HONOR CHARTER SCHOOL
HONOR CHARTER SCHOOL BUILDING CORPORATION
8250 Bent Grass Meadows Drive, Peyton, Colorado 80831
Owner Project No. 3225193
AGENCY NUMBER: AHCA-123456.78

REV. #	DESCRIPTION	DATE
1	AS1 #1 ARE COORDINATION	06/12/26
2	AS1 #2 EPC COMMENTS	06/25/26

DATE OF ISSUE: 04.30.2026
PHASE: CONSTRUCTION DOCUMENTS
ISSUED FOR: CONSTRUCTION PERMIT
GRACE PROJECT NO: 3225193

V1_Lighting Plan.pdf Markup Summary

ELECTRICAL SITE PLAN
1" = 30'-0"

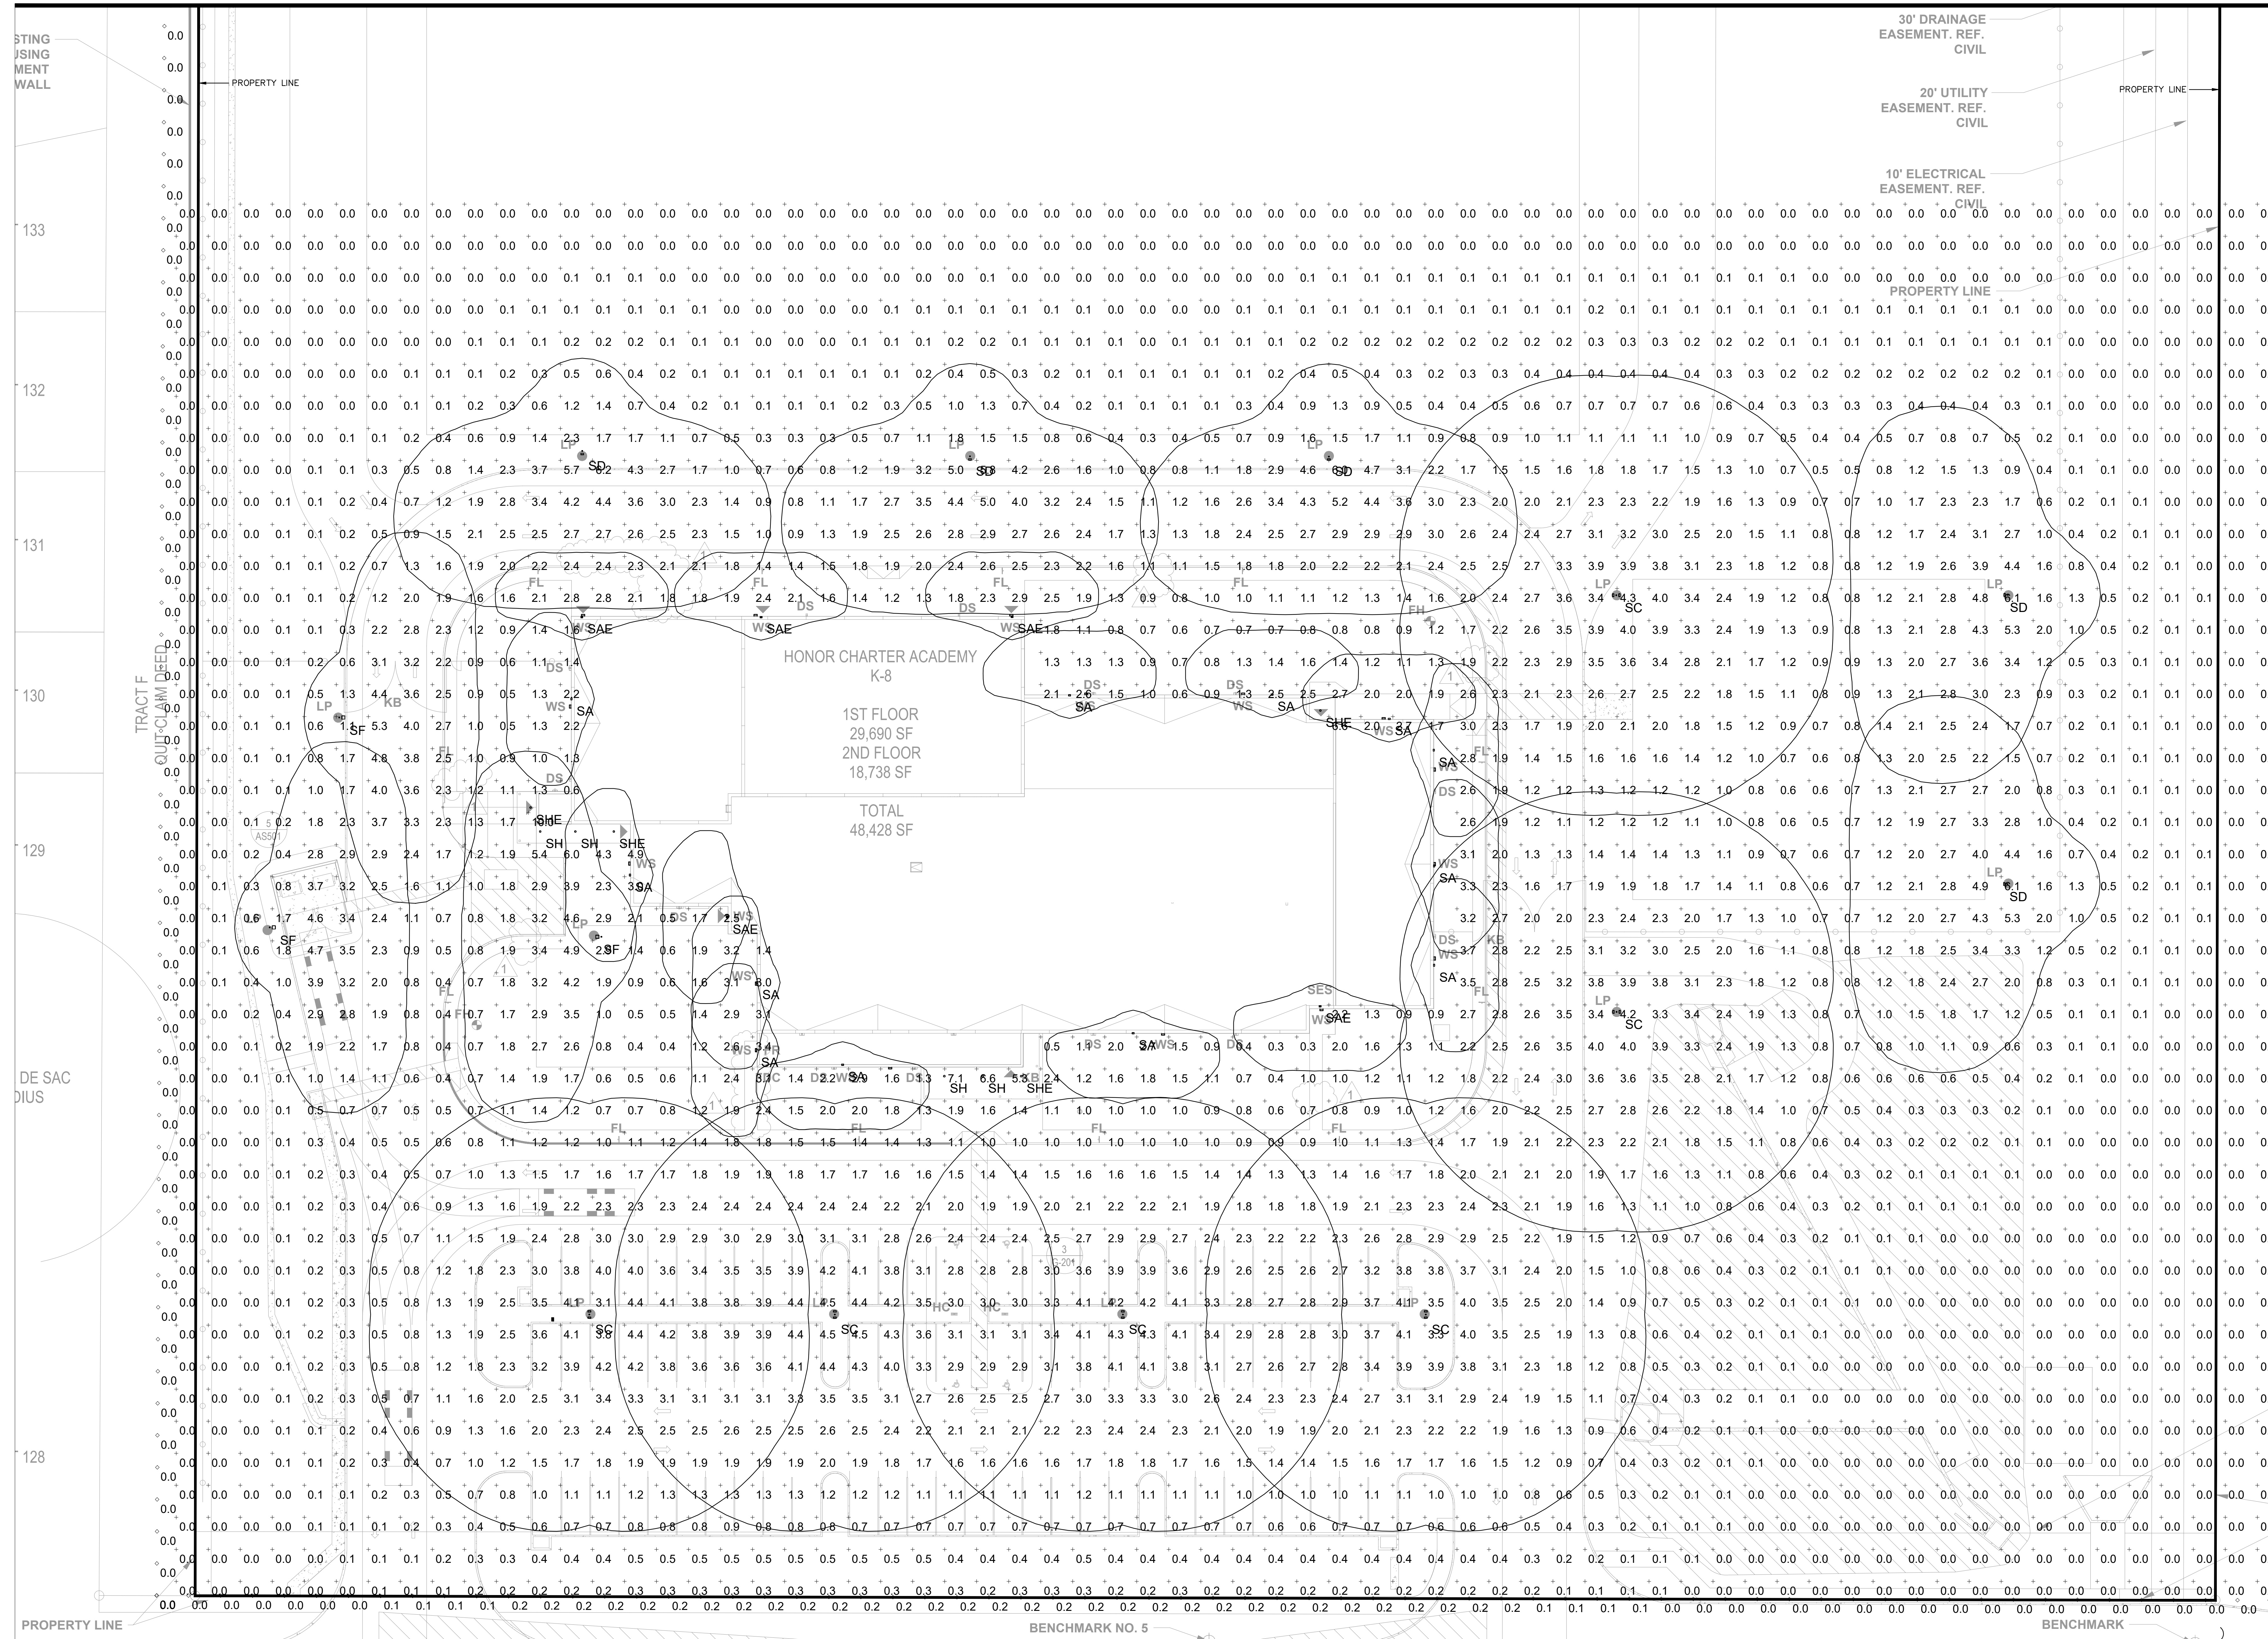
identify hours, height, cut off etc see Land
Development Code, section 6.2.3

identify hours, height,
cut off etc see Land
Development Code,
section 6.2.3

SHUT OFF SCHEDULE IS DESIGNED TO COMPLY WITH THE
ABOVE. SHUT OFF SCHEDULE "NOTE L" HAS BEEN ADDED
TO GENERAL NOTES/ REF SHEET ES-111.

SHUT OFF SCHEDULE IS DESIGNED TO COMPLY WITH THE ABOVE. SHUT OFF SCHEDULE "NOTE L" HAS BEEN ADDED TO GENERAL NOTES/ REF SHEET ES-111.

SITE PHOTOMETRIC PLAN
N.T.S.

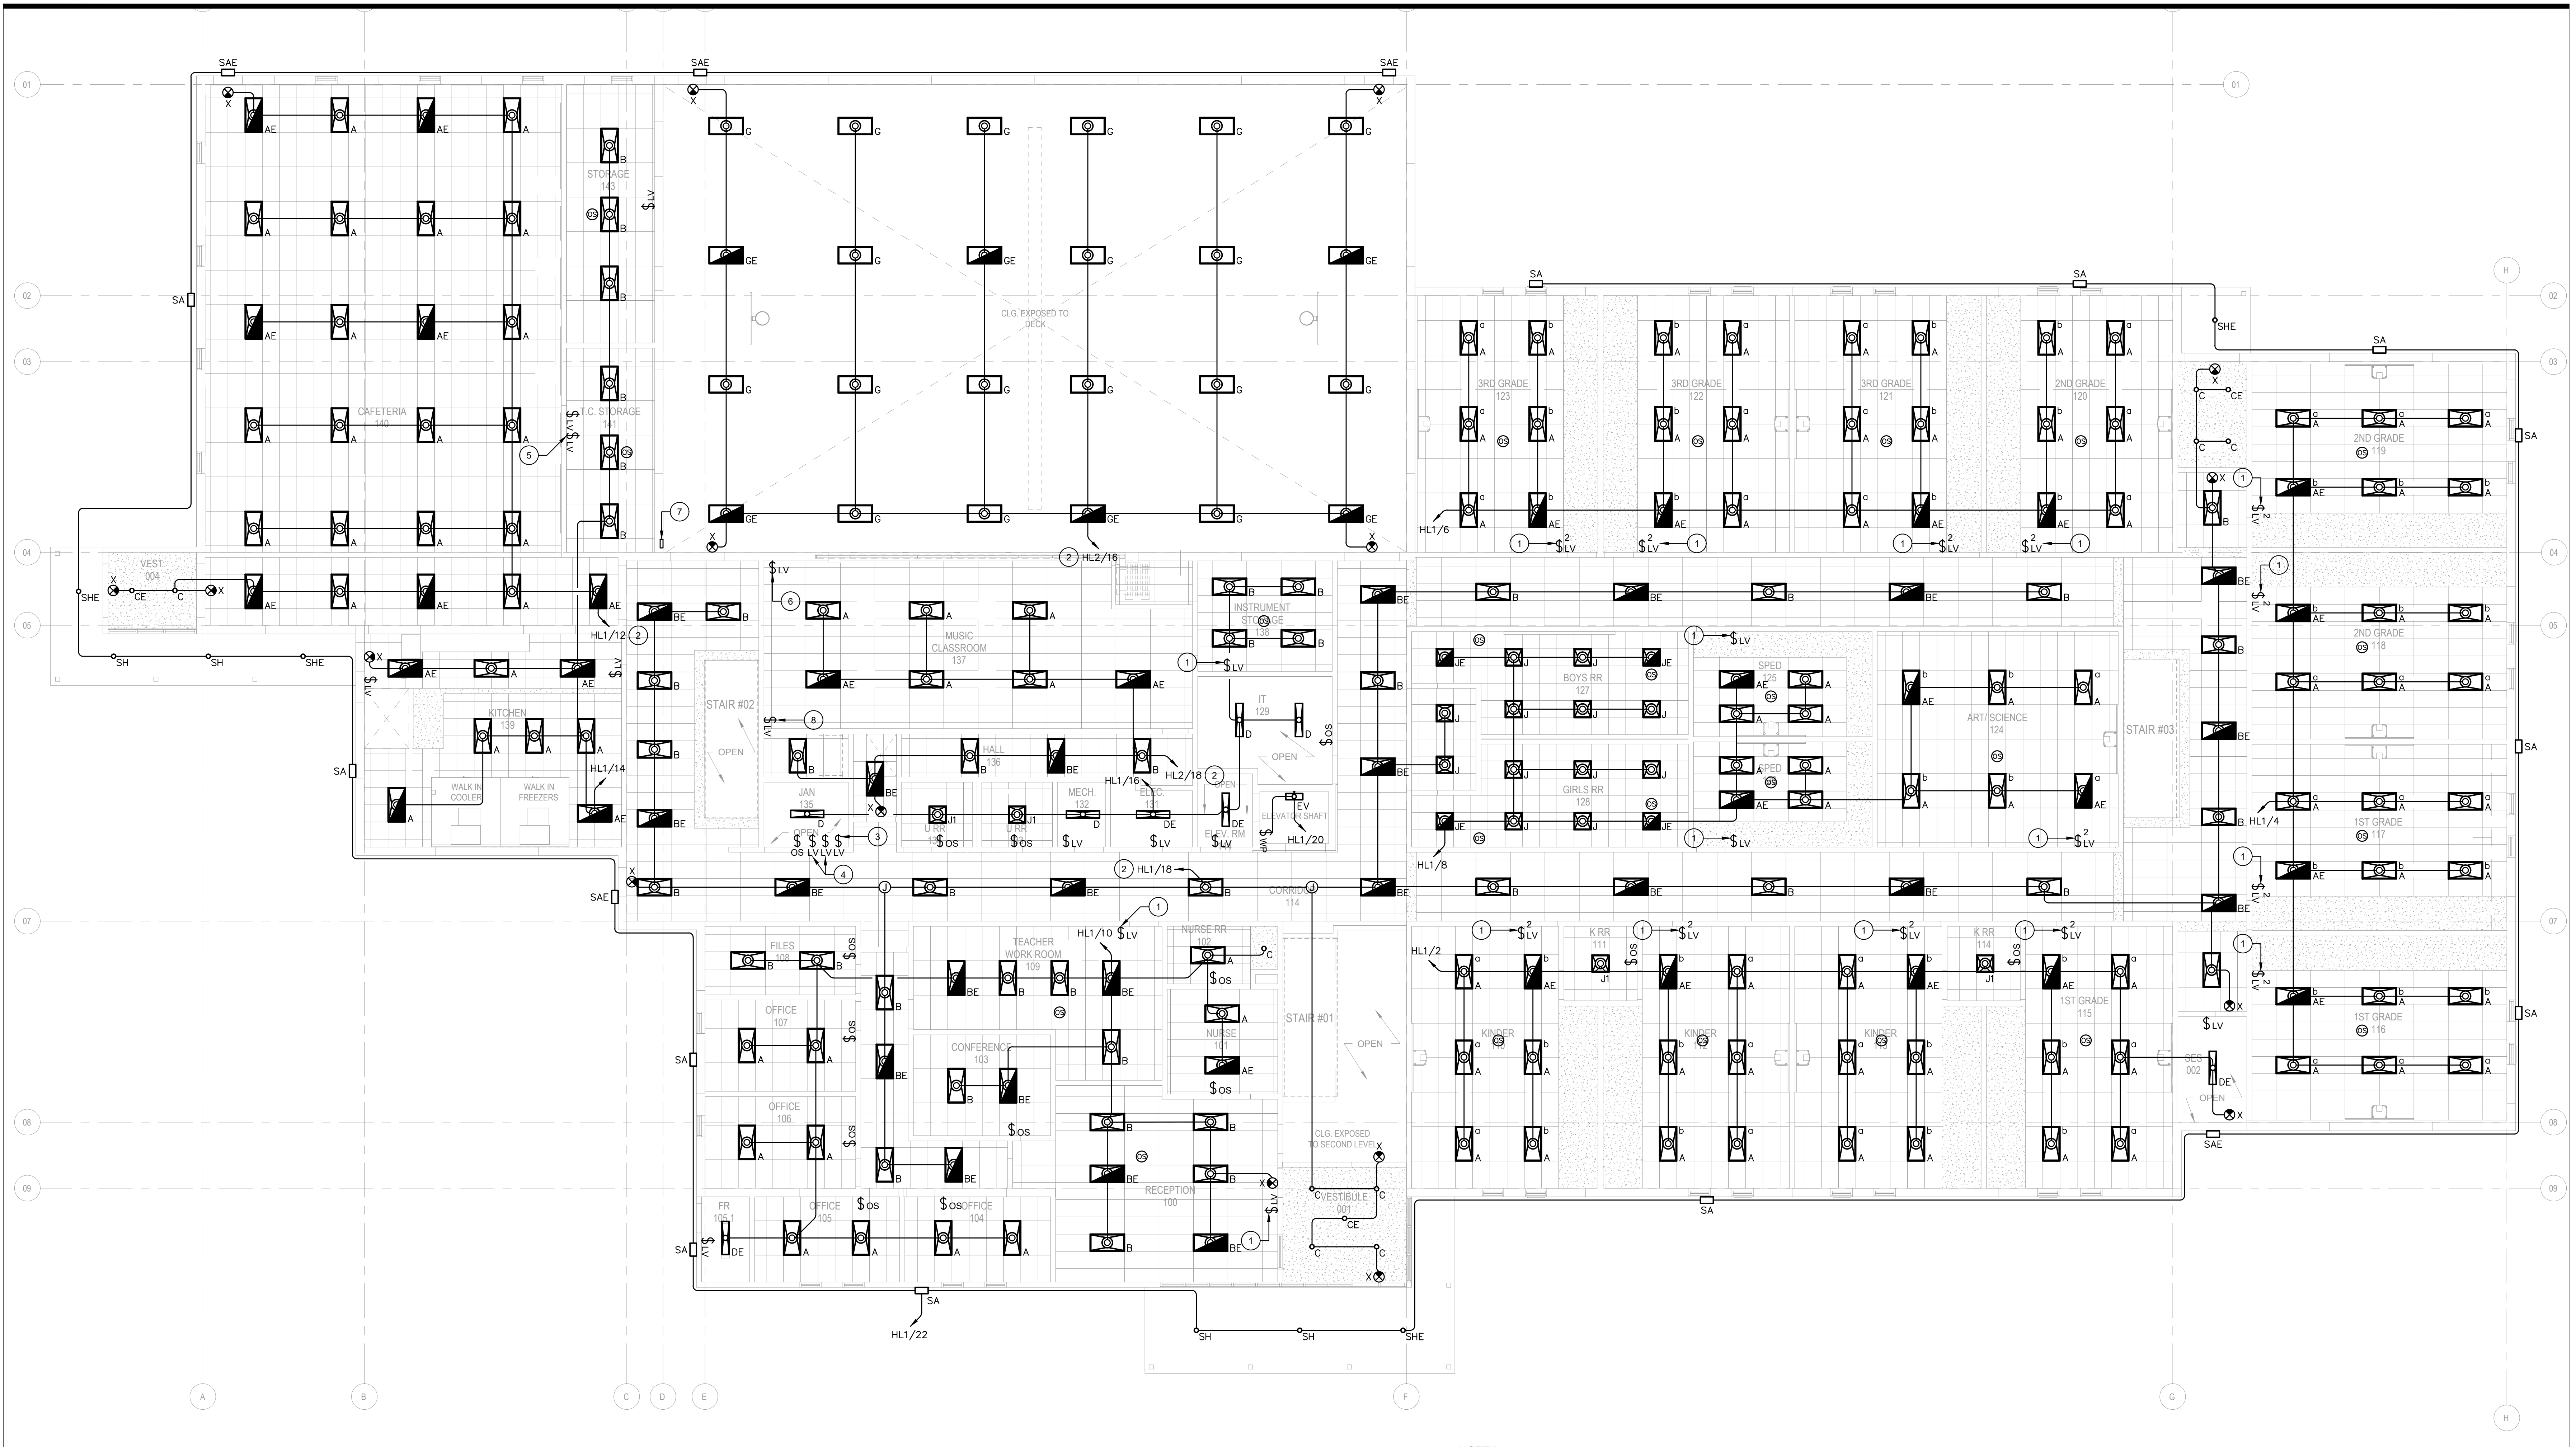
Add property lines and verify full cut off fixtures and provide height of pole mounts. Please see lighting standards in Code

is this sign electric and does it change messages?
provide lumens at property lines

Is this what you are proposing to reduce impacts to residents?

PROPERTY LINES HAVE BEEN IDENTIFIED

1 & 2. DESIGN INTENT IS TO PROVIDE POWER FOR FUTURE SCHOOL SIGNAGE BY OTHERS/ SIGNAGE IS PROPOSED TO BE BACKLIT STATIC SCHOOL NAME AND LOGO

3 & 4. "HOUSE SIDE SHEILDS" HAVE BEEN SPECIFIED AT LIGHT POLES TO REDUCE POTENTIAL GLARE INTO RESIDENTIAL AREAS/ REF SHEET ES-113 FOR CUT SHEETS.

TREES/ LANDSCAPE BUFFERS ARE ALSO PROVIDED AT THE SOUTH PROPERTY LINE TO REDUCE POTENTIAL LIGHT POLUTION.

SECONDARY OPTION "EXTERNAL GLARE SHIELD" IS PROVIDED, SHOULD EPC REQUIRE MORE THAN SPECIFIED.

CONFIRMED/ ALL LUMINAIRES ARE FULL CUT OFF. REF SHEET ES-112.

CONFIRMED/ REF PHOTOMETRIC TABLE.

ALL LIGHT LEVELS ARE BELOW 0.1 AT PROPERTY LINES. NO LIGHT FIXTURES ARE WITHIN 15' OF ADJACENT PROPERTY LINES. "HOUSE SIDE SHIELDS" ARE SPECIFIED. TO REDUCE POTENTIAL GLARE INTO RESIDENTIAL AREAS/ REF SHEET ES-113. SECONDARY OPTION "EXTERNAL GLARE SHIELD" IS PROVIDED, SHOULD EPC REQUIRE MORE THAN SPECIFIED.

'SC'/'SD'/'SF' FIXTURE POLE MOUNTING DETAIL
N.T.S.

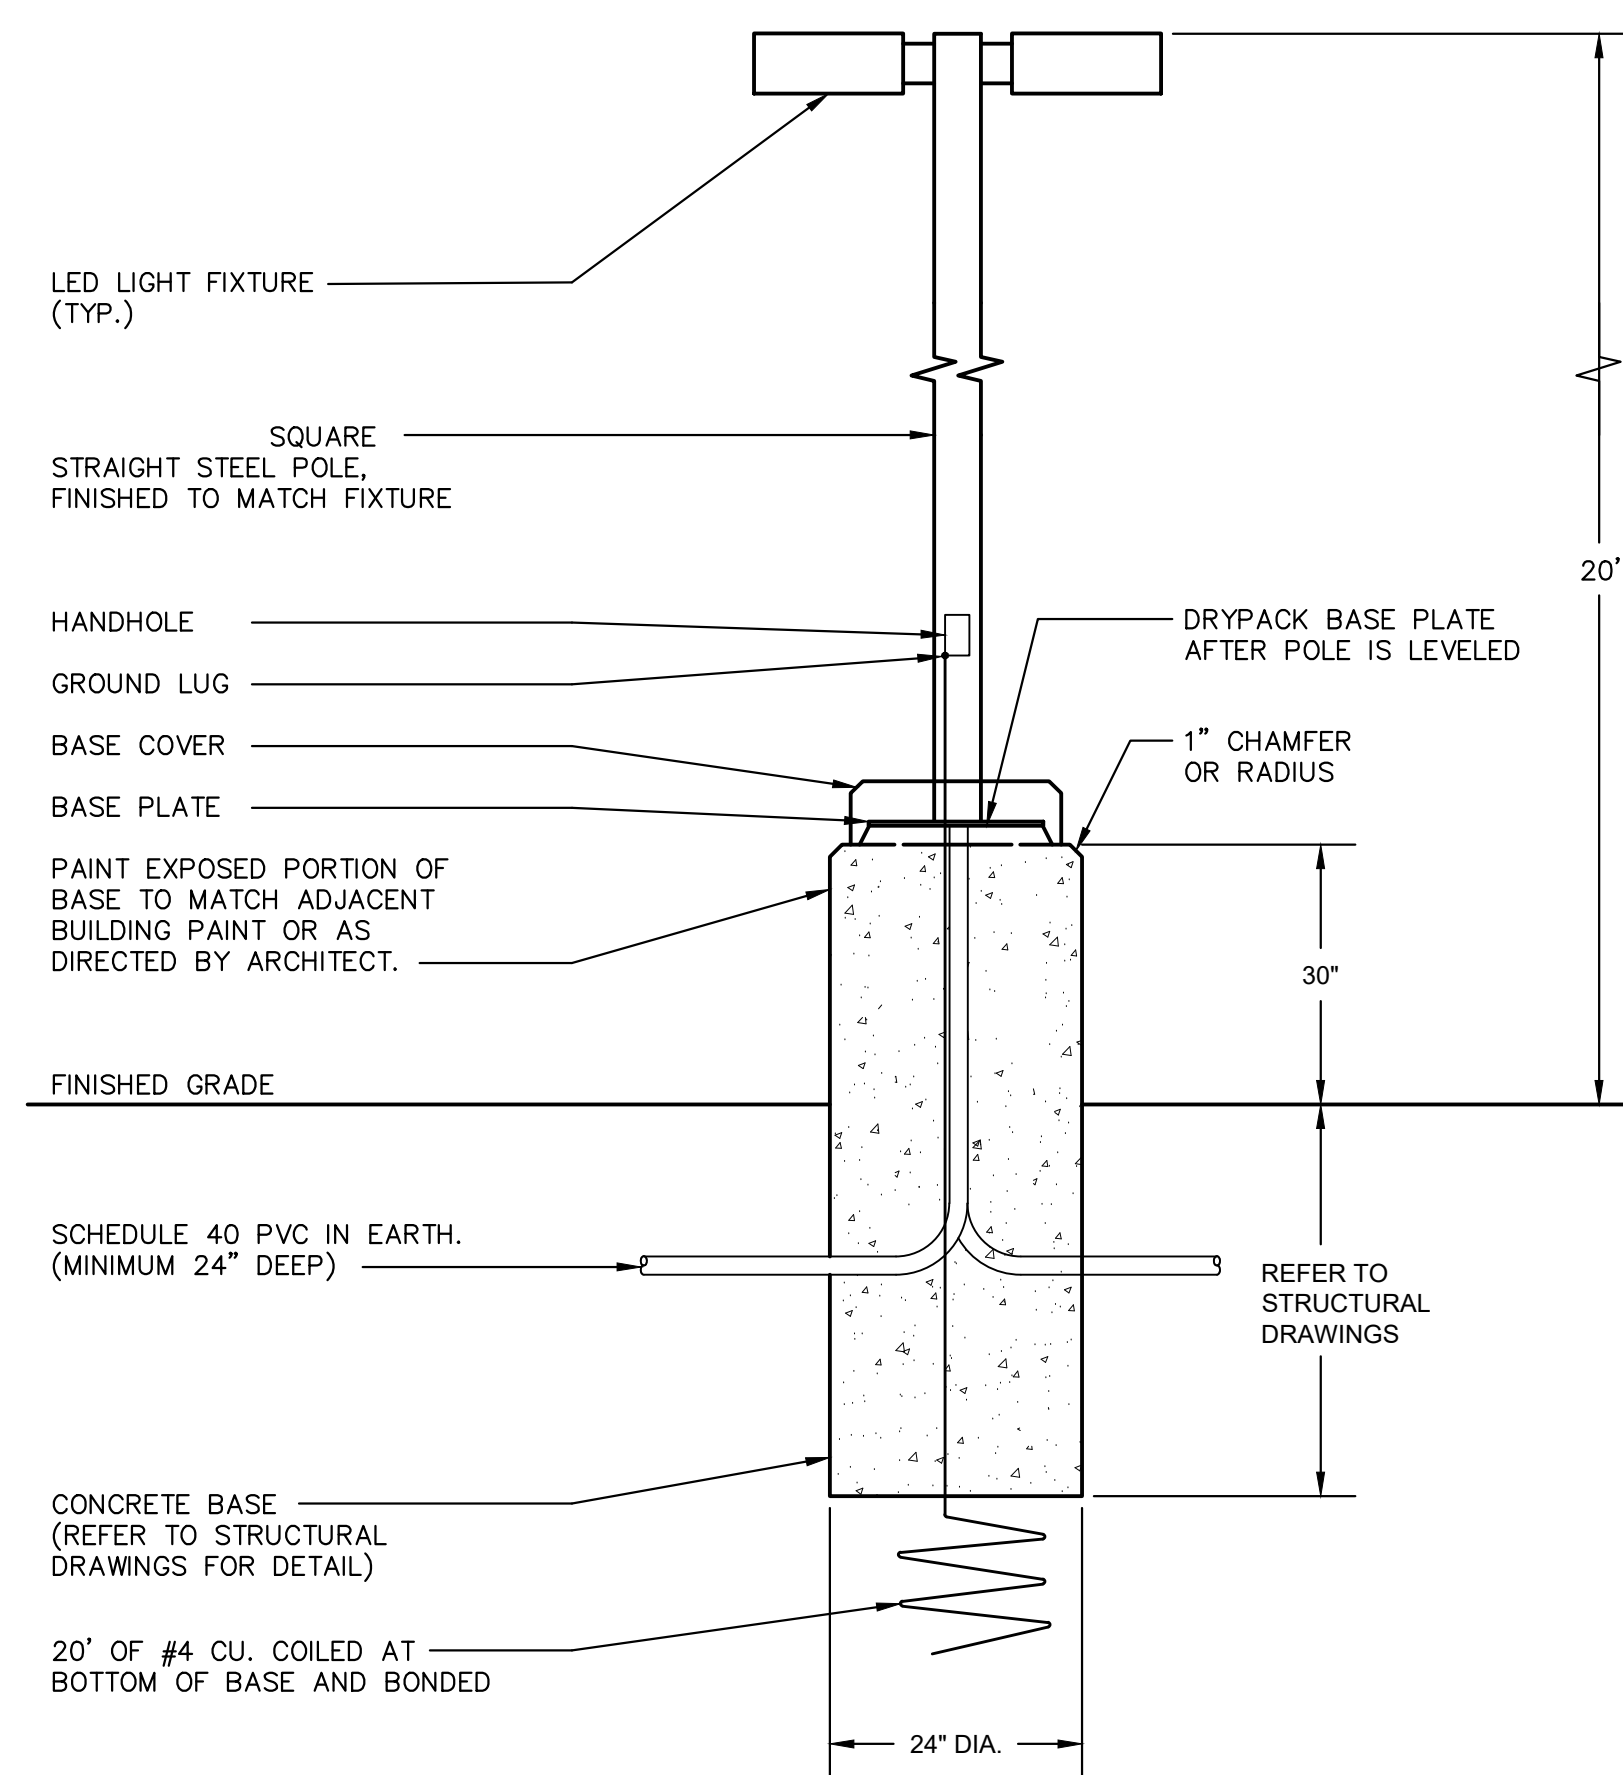
(2)Height. No freestanding light fixtures shall be mounted higher than 15 feet, except parking lot light fixtures which shall be mounted no higher than 20 feet unless an alternative lighting proposal is approved in accordance with this Code.

LIGHT POLES ARE DESIGNED TO THE ABOVE STANDARD/ REF SHEET E-802 FOR DETAIL. THERE ARE NO LIT BOLLARDS OR ILLUMINATED LANDSCAPING SPECIFIED ON THIS PROJECT.

CONFIRMED/ REFER TO SHEET E-802 FOR PARKING LOT LIGHTING DETAILS.
